# Access Compliance Report Public Rights-of-Way (Curb Ramps)

Intersection ID: 14512	Main Street: CARONIA_ST	Cross Street: ROSS_AV	Location: NE
ADA ID: A030BBE4CECE	Ramp Type: PerpDiag	Initial Pass/Fail: Fail	Overall Compliance: No Severity Score: 1.25

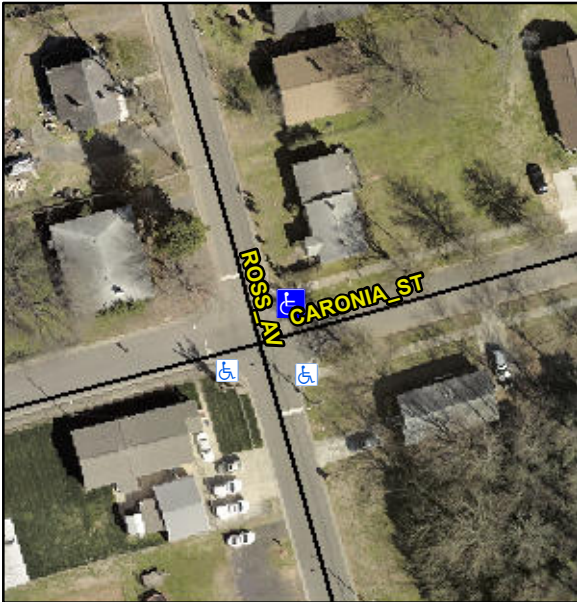
PROW/ADA:  
**Not Found, R304.5.3**

Compliance	Description	Data	Compliance	Description	Data
N/A	Ramp Length (in)	59.0	Yes	Ramp Slope (%)	7.3
Yes	Ramp Width (in)	48.0	No	Ramp XSlope (%)	2.3
N/A	Flare Type LT	N/A	N/A	Flare Type RT	N/A
N/A	Flare Slope LT (%)	N/A	N/A	Flare Slope RT (%)	N/A
N/A	Flare Traversable LT?	N/A	N/A	Flare Traversable RT?	N/A
N/A	Landing Length (in)	N/A	N/A	DWS Provided?	N/A
N/A	Landing Width (in)	N/A	N/A	DWS Contrast?	N/A
N/A	Landing Slope (%)	N/A	N/A	DWS Length (in)	N/A
N/A	Landing X Slope (%)	N/A	N/A	DWS Full Width?	N/A
N/A	Landing Curb? (Y/N)	N/A	N/A	DWS Offset (in)	N/A
N/A	Shared Landing?	N/A			
N/A	Gutter Ponding?	N/A	N/A	Gutter Slope (%)	N/A
N/A	Gutter Lip Ht (in)	N/A	N/A	Gutter X Slope (%)	N/A
N/A	Painted X Walk1?	No	N/A	Painted X Walk2?	No
	X Walk 1 Direction	To S		X Walk 2 Direction	To W
N/A	X Walk 1 Width (in)	N/A	N/A	X Walk 2 Width (in)	N/A
	X Walk 1 Slope (%)	1.5		X Walk 2 Slope (%)	5.8
	X Walk 1 X Slope (%)	2.9		X Walk 2 X Slope (%)	0.7

Possible Solutions:  
**Remove & Replace Curb Ramp With Two New Directional Ramps or Equivalent.**
